2 Type of change

Product Change Notification					PCN-Changes to Tape and Reel Packaging		
owner	creation date	release date	released by	change order no	rev	page	D10-032-807
schmidre	19.12.2018	19.12.2018	haeckima	2016867	A	1 of 2

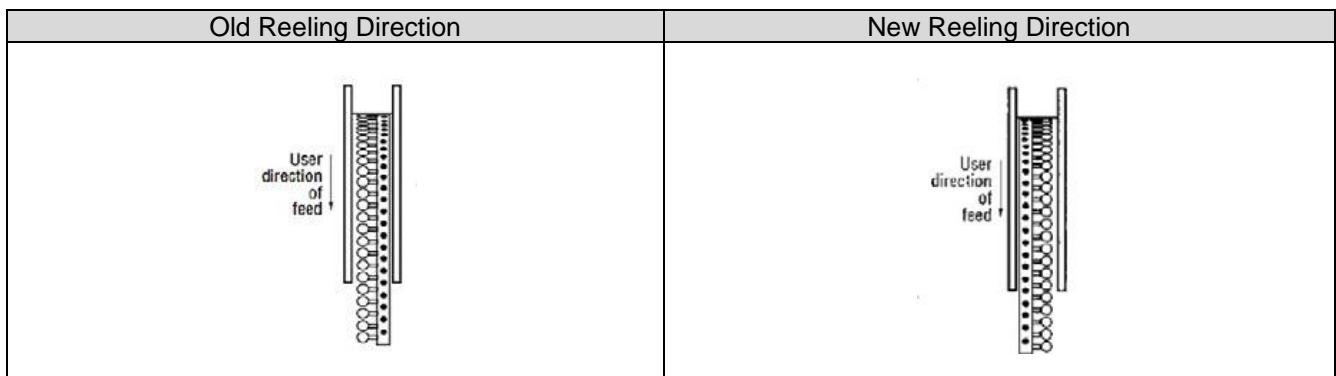
The total length of the leads will be shortened as shown in the example pictures below. The actual dimension changes will vary between models. Assuming the components are removed from the tape and reel packaging by cutting the leads at the tape edge, the form, fit and function of the components are not affected. There is no change in the mechanical, electrical or material properties, and the components' performance and agency recognition remains the same.

In the same step we take the chance to improve our conformity with EIA-468 by changing the reeling direction. If there are major production obstacles occurring due to this change, please get in contact with your local SCHURTER sales representative.
